STAFF REPORT

Community Planning and Preservation Commission Certificate of Appropriateness Request

Case No.:	21-90200048
Request:	Review of a Certificate of Appropriateness for the addition of a front porch to 3200 8 th Ave. N., a contributing property located within a local historic district.
Address:	3200 8 th Ave. N.
Legal Description:	KENWOOD SUB ADD BLK 17, LOT 1 & E 5FT OF LOT 2
Parcel ID No.:	14-31-16-46350-017-0010
Date of Construction:	1949
Local Landmark:	Kenwood Section – Northwest Kenwood Local Historic District (18-90300008)
Owners:	Rachel L. Freeman Joseph R. Warpinski

Figure 2: Proposed front elevation

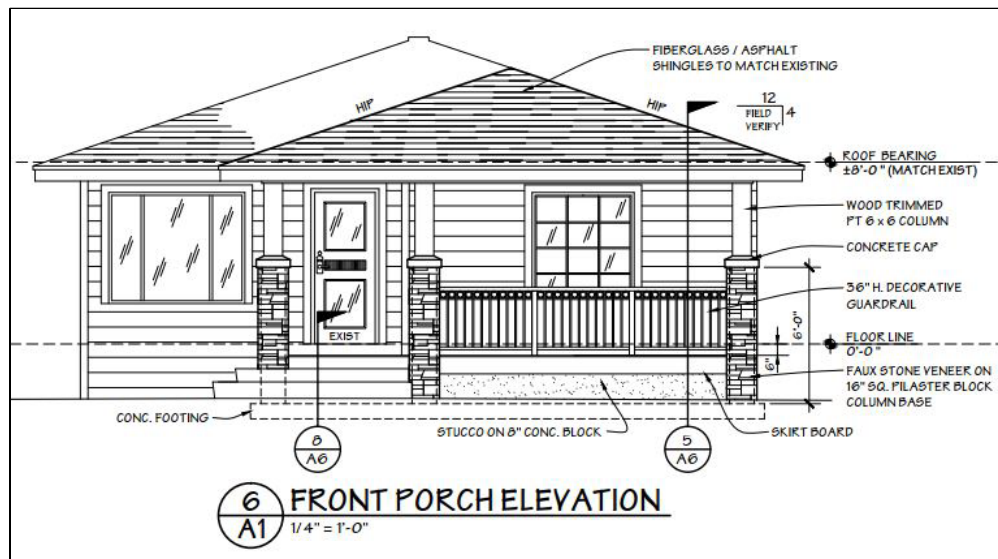
Although the proposal was designed to blend in with the subject district as a whole, staff has concerns with the extent to which it will alter the historic form of the subject property itself, which was designed without a front porch.

As noted above, although the proposal does take cues from properties throughout the district, the subject property's simple form at the front elevation is a character defining feature.

Staff recommends that the applicant revise the flagstone cladding proposed for the columns and provide plans for a simple wooden railing.

1. The proposed porch columns and railings will be revised to feature a straight, square column design and straight metal or wood railings subject to administrative approval.
2. All other necessary permits shall be obtained. Any additional work shall be presented to staff for determination of the necessity of additional COA approval.
3. This approval will be valid for 24 months from the date of action, June 8, 2023.

6 FRONT PORCH ELEVATION
A1 1/4" = 1'-0"

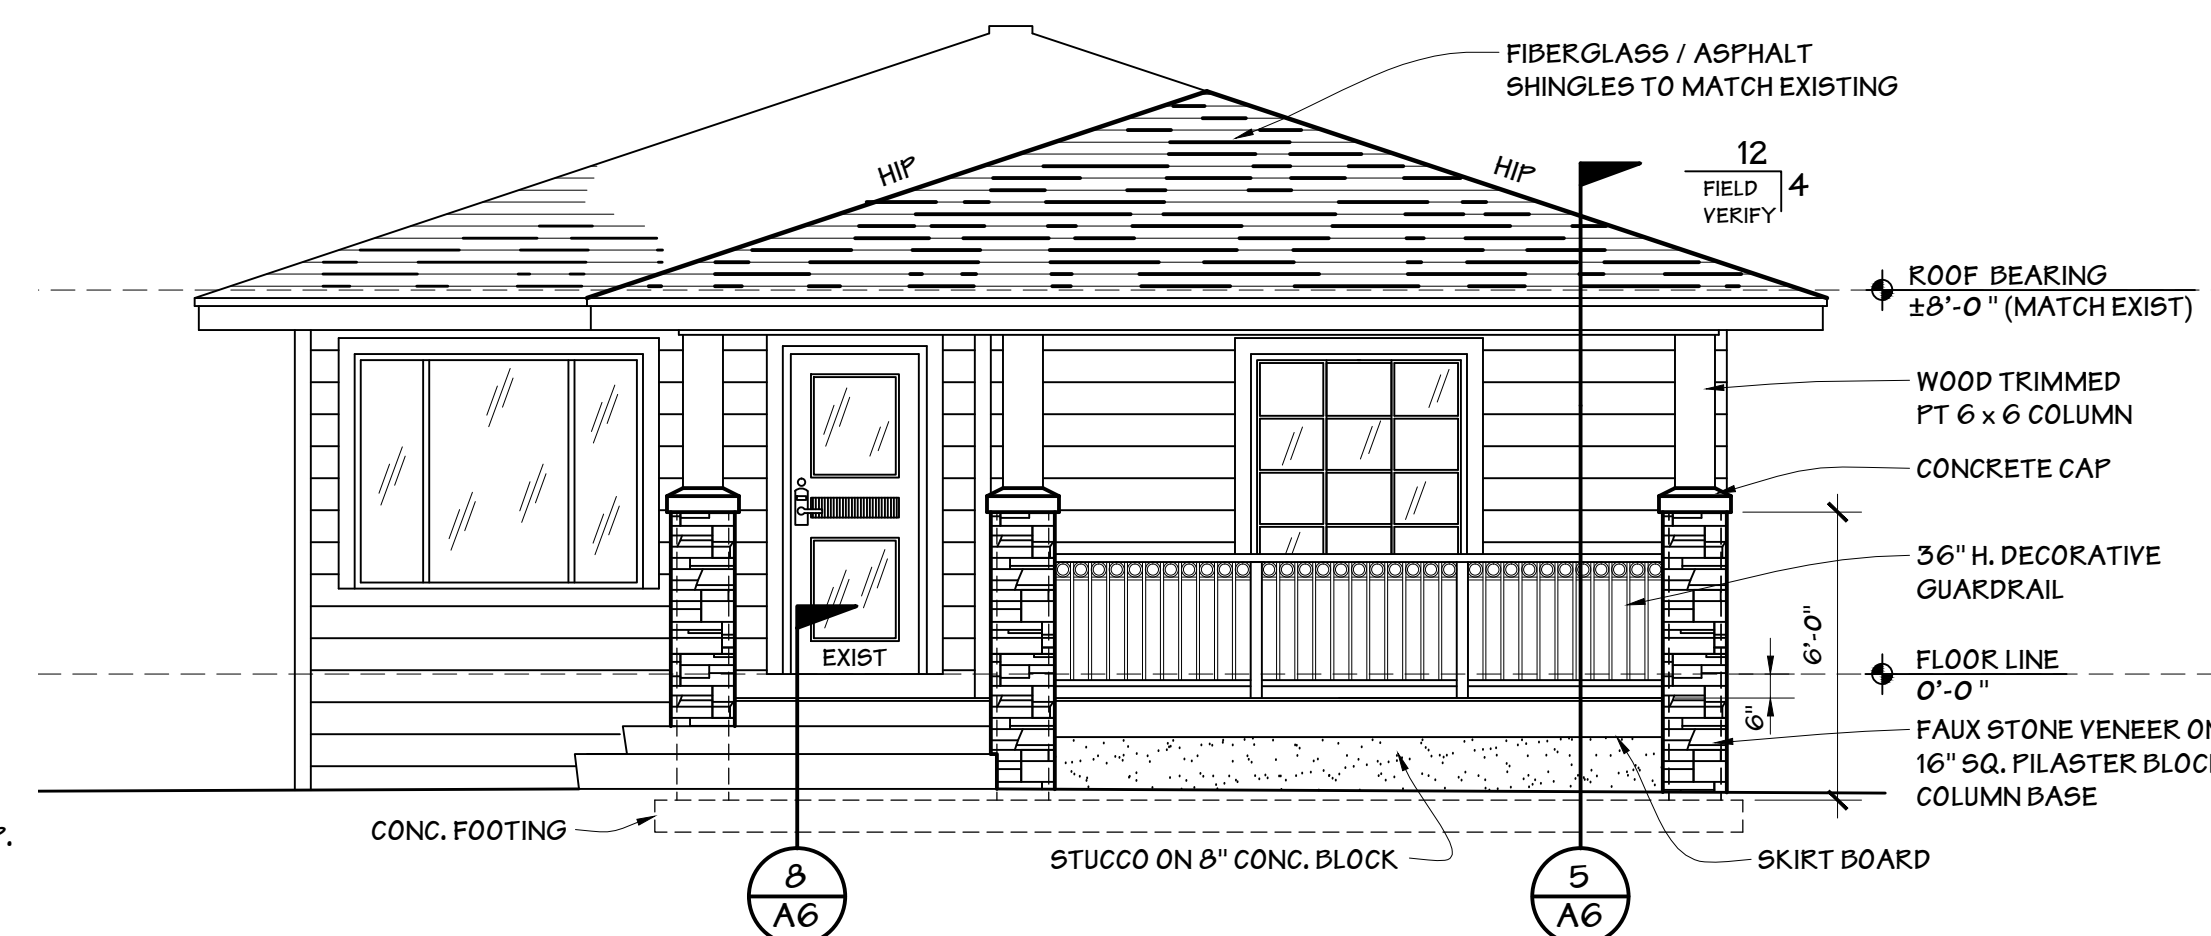
Proposed decorative elements include a faux "flagstone" style veneer base below square wood uppers at the porch columns. Proposed railings are noted only to be 36 in high decorative guiderails; material is not specified.

More information about the proposed porch railings is requested by staff for administrative approval.
